RESUBMIT APPROVED AS NOTED
BY C. CARLSON DATE 07-27-2012

PROJECT: VT RT 9, BRIDGE NO. 11
TOWN OF WOODFORD, VT
OVER WALDOOMSAC RIVER

TITLE: GIRDER 105G1

REFERENCES: PROJECT NO. ER BHF 010-1 (44)

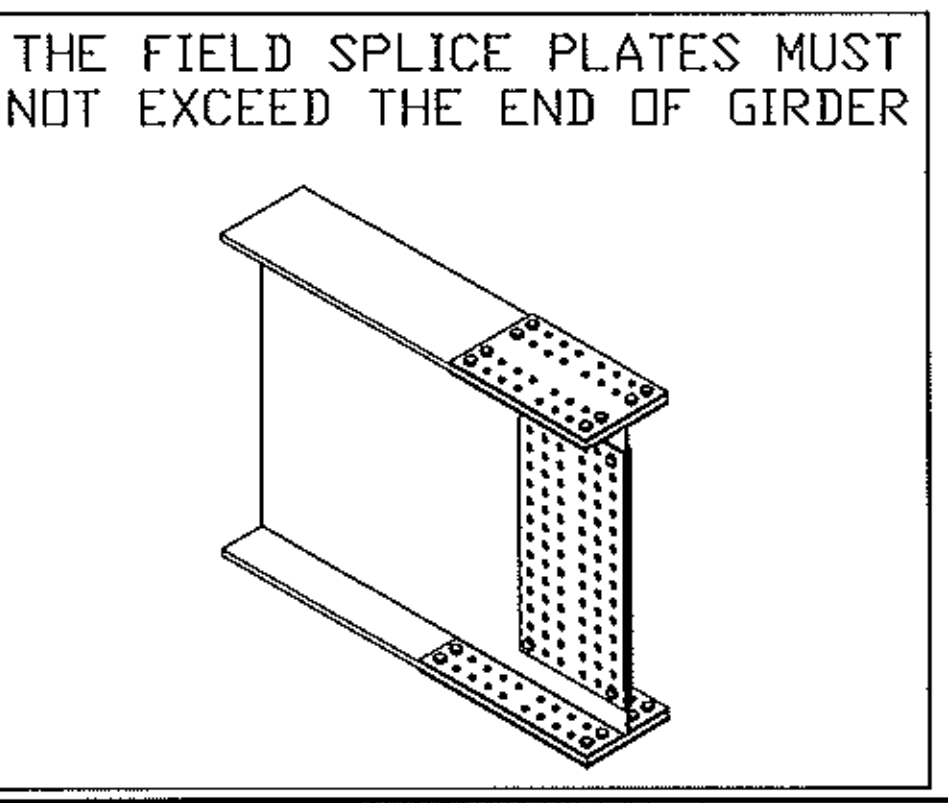
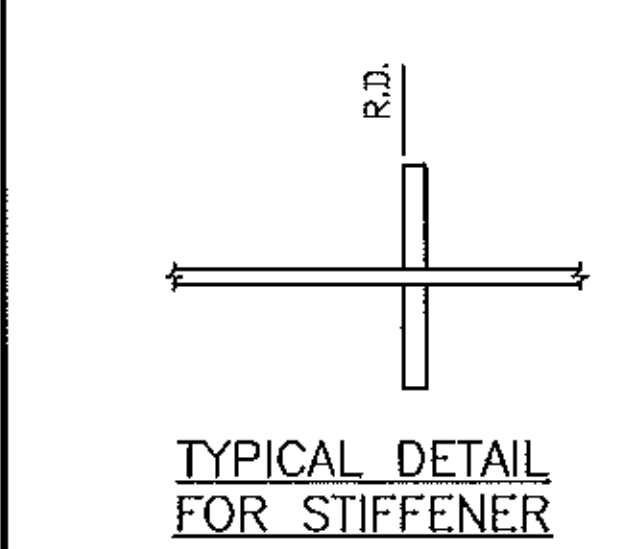
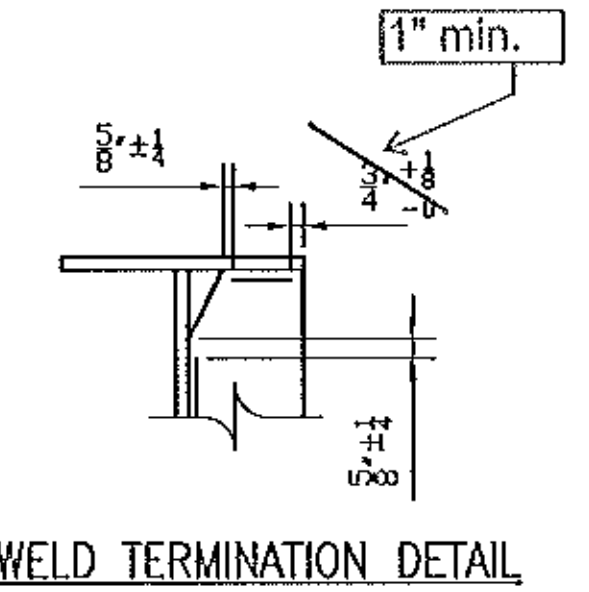
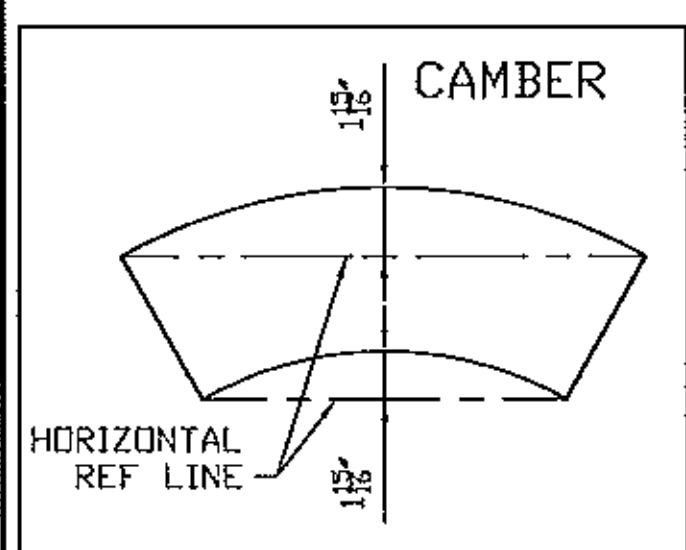
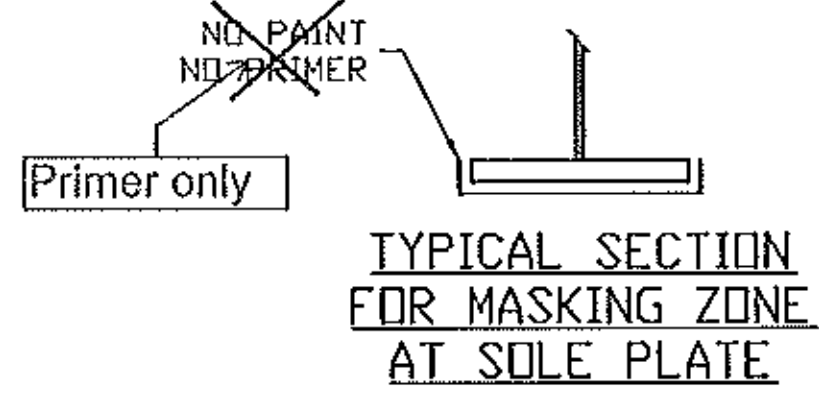
Is there room for WPS S-1001 with dart welder? There is only 5 3/4" between the two plates Typ. all girders.

See standard specification 506.24(a)(9), no payment will be made for bolts, nuts, washers, they are considered to be incidental
